Final Supplemental Environmental Impact Report

Gateway South Office Building and Fire Station

City of Scotts Valley

September 2005

GATEWAY SOUTH
 SCOTTIS VALLEY, CALIFORNIA

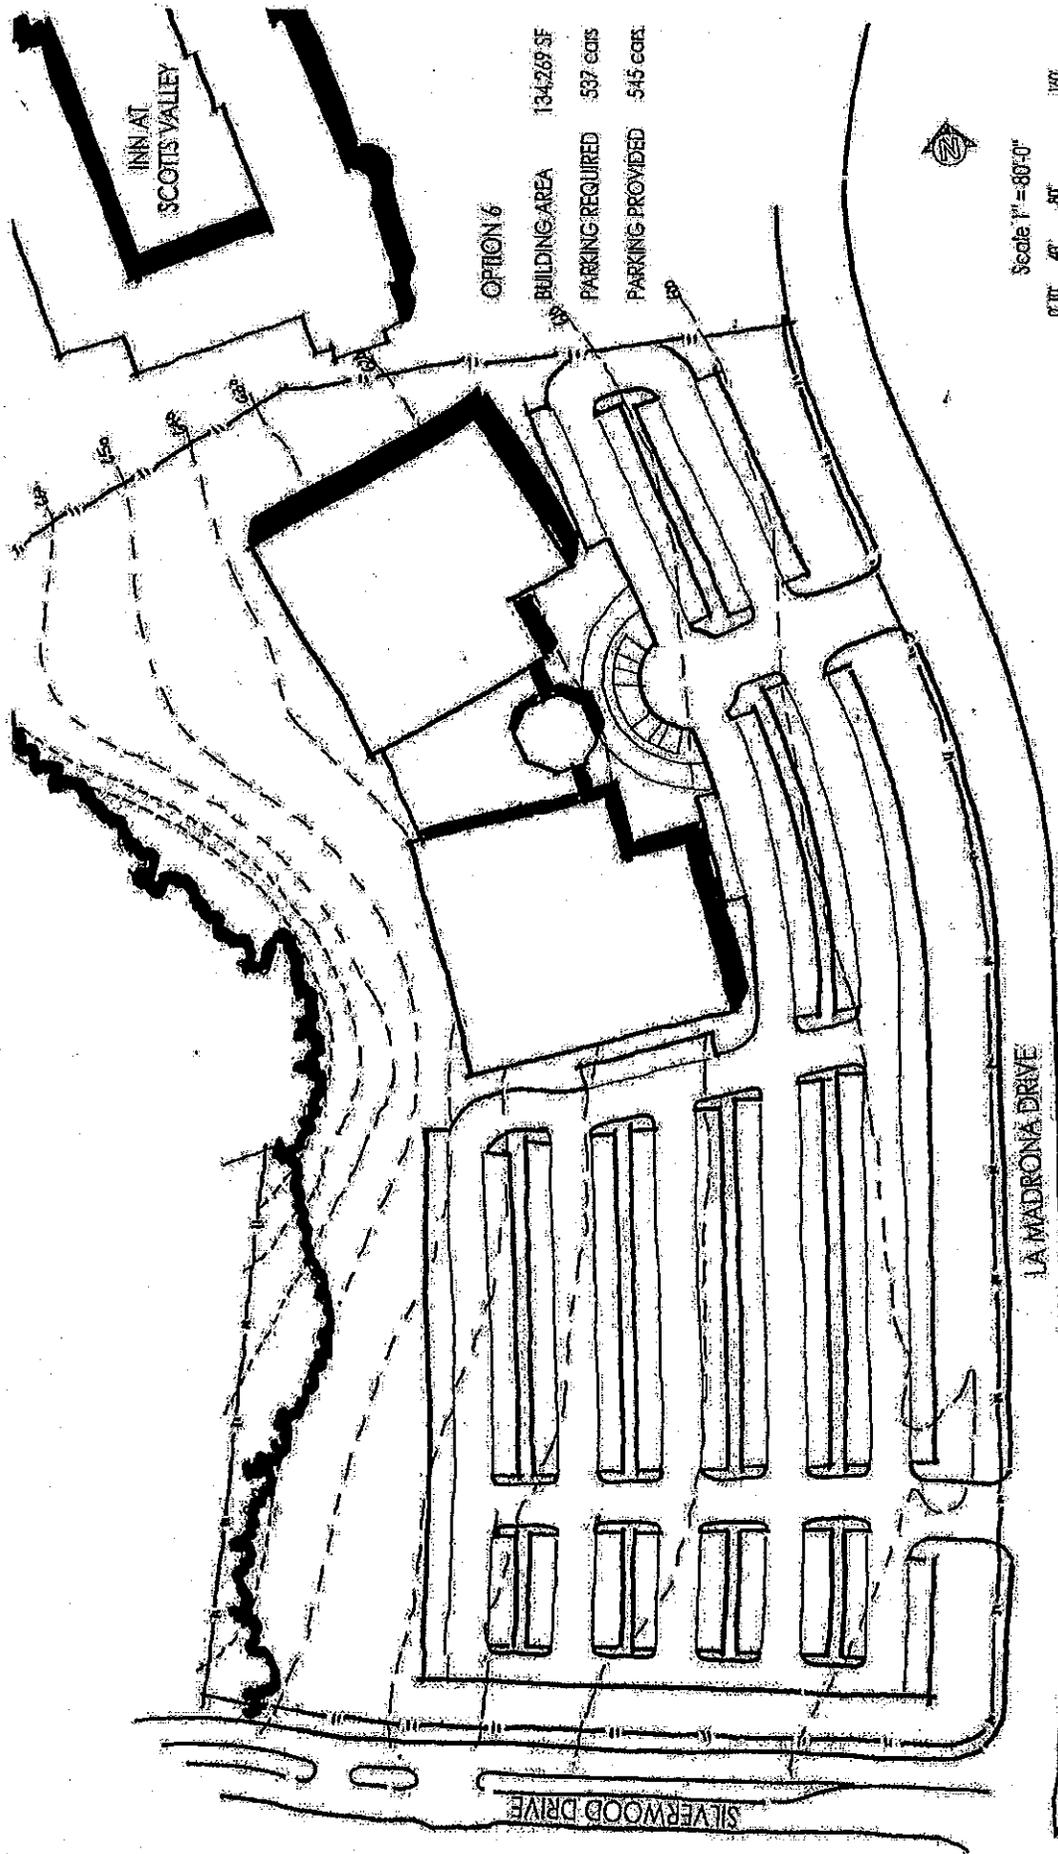
15. Please expand the discussion of alternatives. Couldn't there be an alternative that reduces some of the impacts; e.g., reducing the amount of impervious surface, possibly by providing underground parking; locating the building closer to the Hilton Hotel so that the developments are seen as a visually integrated, cohesive unit; and reducing the amount of cut and fill on the site?

Response: The examination of alternatives as required by CEQA Guidelines, Section 15126.6, includes consideration of other ways of feasibly attaining most of the basic objectives of the project and avoiding or substantially lessening any of the significant effects of the project. In response to the comment to explore other development options, the project architects, DES, developed design options based on suggestions from the Commissioners and Councilmembers. These alternatives are summarized below and illustrated in the following figures labeled Option 1 through Option 6.

While there are notable planning and design differences among these options (stemming from the variations in massing and the ease of accessibility of the building from the parking areas), they result in similar less-than-significant impacts on visual resources and quality. Those options involving more grading than the proposed project have potentially greater runoff and geoseismic impacts. In addition, development of the proposed office building at the northern end of the site raises greater concerns for two issues: fire hazards and disturbance to protected trees. According to the Fire Department, the options of siting the office building closer to the Hilton Hotel would increase the potential for fire to spread between the buildings and to the surrounding grasslands. The northern end of the site between 640 and

Page 3.1-23, Figure 3.1-2: Replace with the new figure on the following page.

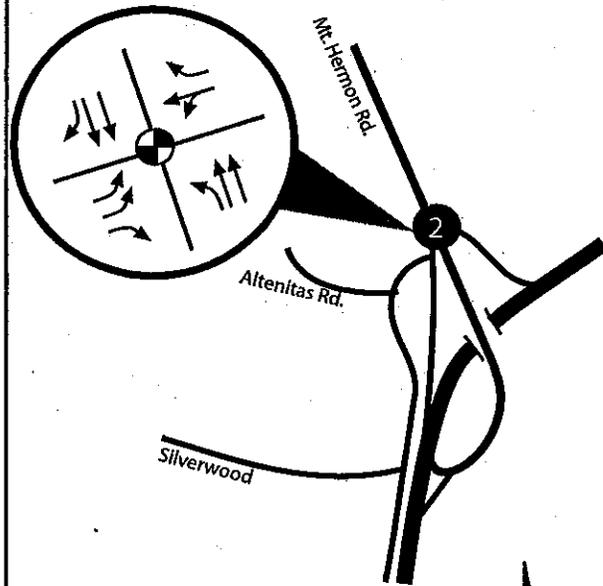
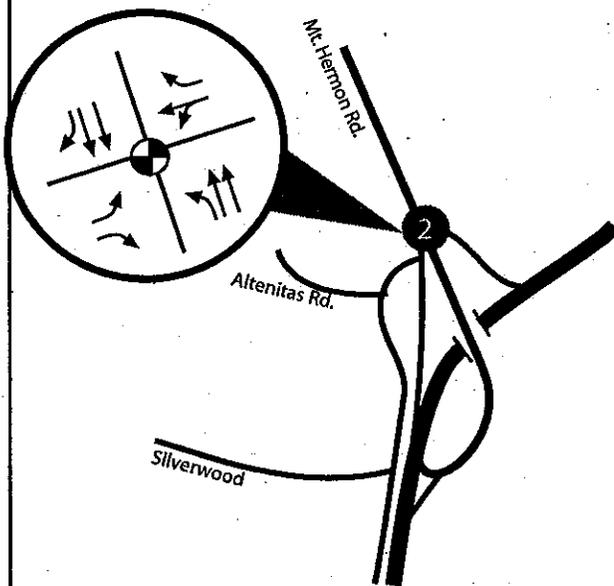
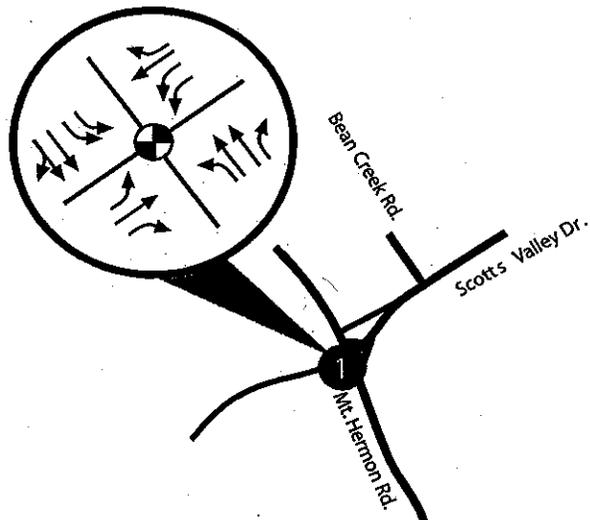
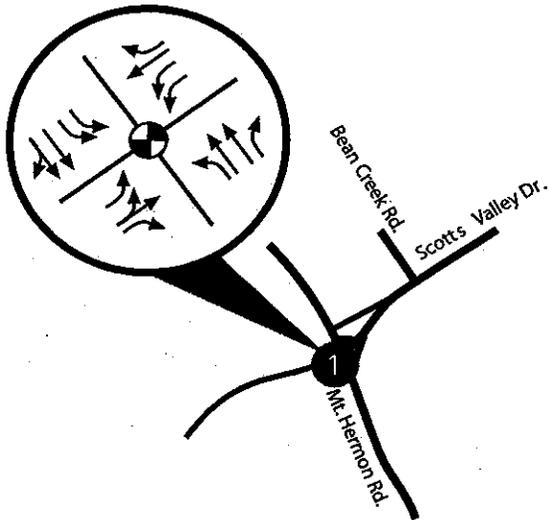
4. TR 1.1 - As discussed, the geometrics textual discussion should be consistent with figure 3.1-2. A shared left-through on the La Madrona Road approach is inconsistent with the facing southbound off ramp.

TR9.3: Westbound Mt. Hermon Road already has a dedicated right-turn lane, albeit, it somewhat narrower than desired. Glen Canyon Road has another dedicated left-turn lane. Figure 3.1-2's north arrow implies that Mt. Hermon Road is more of north-south roadway than an east-west as presented by the author.] 7.6

- 3.4 Mitigation Measure TR-1.1, as noted by the commentor, does not present the correct lane configuration for the intersection at Mt. Hermon Road/La Madrona/SR-17 Southbound off-ramp. In addition, the proposed improvements identified by the corrected Mitigation Measure TR-1.1 are currently being implemented as mitigation for the approved Schilling project across La Madrona Drive from the proposed Gateway South Office Building and north of the teardrop parcel proposed to house the future fire station. Accordingly, the mitigation measure is revised to require the project sponsor to contribute to the improvements being made by the Schilling project sponsor. The correct intersection improvements are shown in Figure 3.1-2 (presented later in this section after the heading "Staff Initiated Text Changes") and the text is revised as follows:

- 7.6 Mitigation Measure TR-9.3 is no longer necessary based on re-evaluation of the impacts; therefore, the corrections to the figure for this intersection are no longer relevant.
